**Re: Dunkin Donuts**  
**2301 Juan Tabo Blvd NE**  
Architect's Stamp dated 01-08-16 (H21D051)  
Certification dated 08-16-16

**RE: Traffic Certification for TCL – Dunkin Donuts at 2301 Juan Tabo Blvd. NE**

NEW DUNKIN DONUTS  
2301 JUAN TABO BLVD NE  
SITE PLAN, SITE DATA  
AND TCL  
PC NUMBER

1 ARCHITECTURAL SITE PLAN / TCL

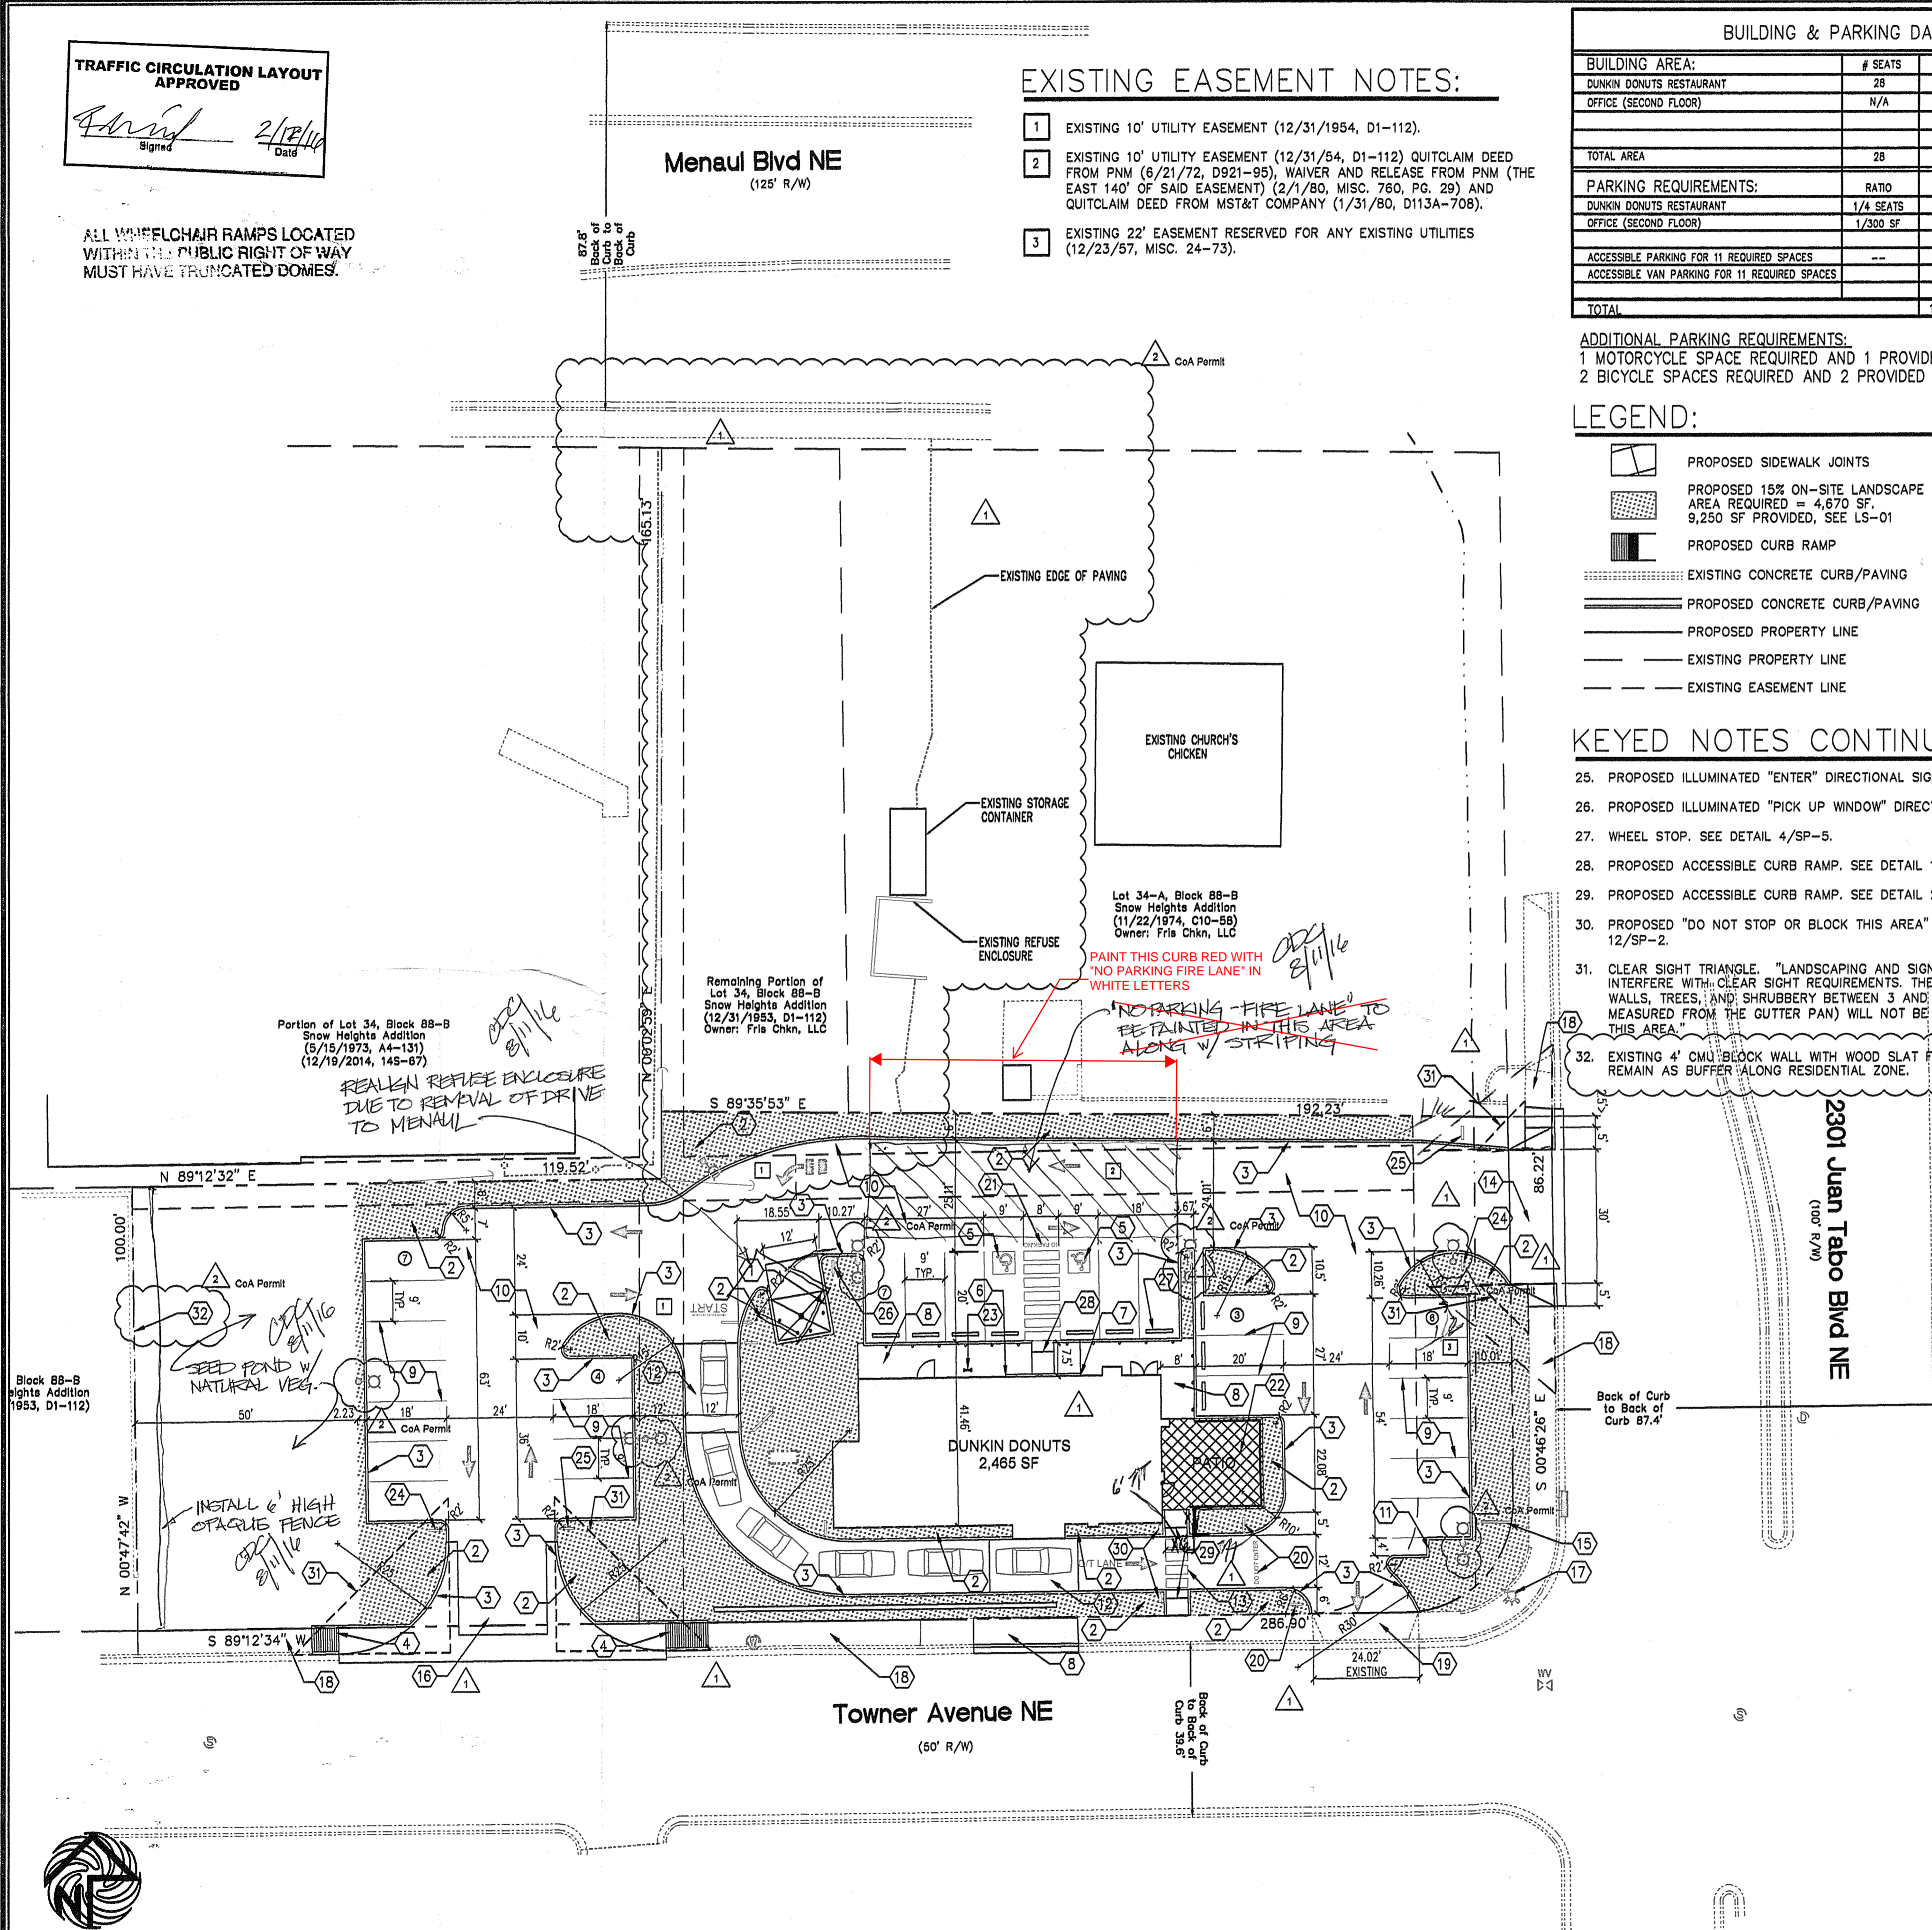
1. Paint header curb, on north side of the property and across from the accessible parking, red with "NO PARKING FIRE LANE" painted in white letters.

I further certify that Craig Calvert, Project Manager at Modulus Architects, personally visited the site on 8-16-16 and has determined by visual inspection that the corrections noted above were installed at that time. This certification is submitted in support of a request for a permanent certificate of occupancy.
